Re: Safety Defect Report

**SUBJECT: RECALL CAMPAIGN - 00229  
(1996-1999 TIOGA, JAMBOREE SPARE WHEEL)**

# RECALL SERVICE BULLETIN

## Spare Wheel Replacement

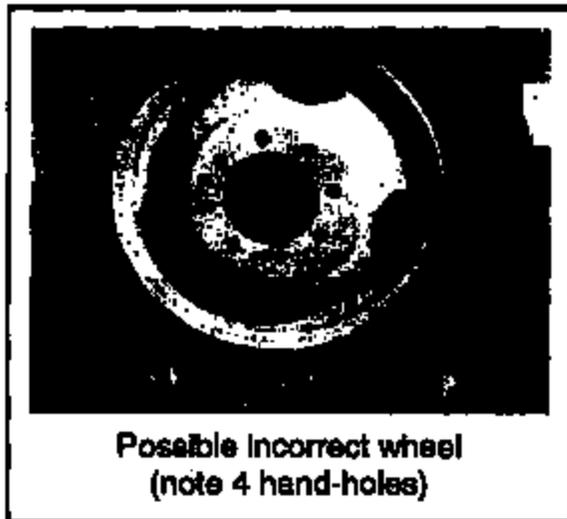
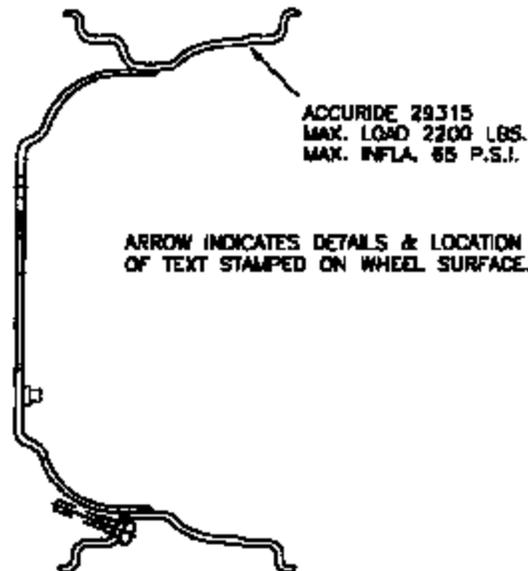
This Recall Service Bulletin describes the procedure to inspect and replace a wheel originally installed at the manufacturing plant as a spare wheel.

1. Remove the spare tire cover and wheel covers (if installed).
2. Visually inspect the spare tire wheel *and* all six ground-contact wheels to determine if any have four oval hand-holes (see photo). *If any wheel has four hand-holes, follow step 3 closely.*

3. If any wheel on the coach has four hand-holes, you must verify the stampings on the wheel.  
Most four-hole wheels are the incorrect wheel, although a few may be correct.
  - a. Clean the back or dished side of the four-hole wheel.
  - b. Locate the manufacturer's stampings on the wheel, near the bead area.
  - c. The incorrect four-hole wheel can be identified by the stamping "Accuride 29315, max. load of 2200 lbs, max. inflation of 65 psi". This wheel must be replaced.

- d. The correct four-hole wheel has the stamping "RUDEVECA VENEZUELA". A wheel with this stamping should not be replaced.

4. For all wheels requiring replacement, dismount the tire and remount and balance the tire (including new valve stem) according to normal tire installation and balancing methods.
5. Install any new ground contact wheel and tire assemblies. Torque wheel nuts to 140 lbs./ft. Install any wheel simulators or wheel covers removed in previous steps.
6. Attach spare tire assembly securely to the coach, install spare tire cover (if necessary) and return coach to customer in a clean condition.
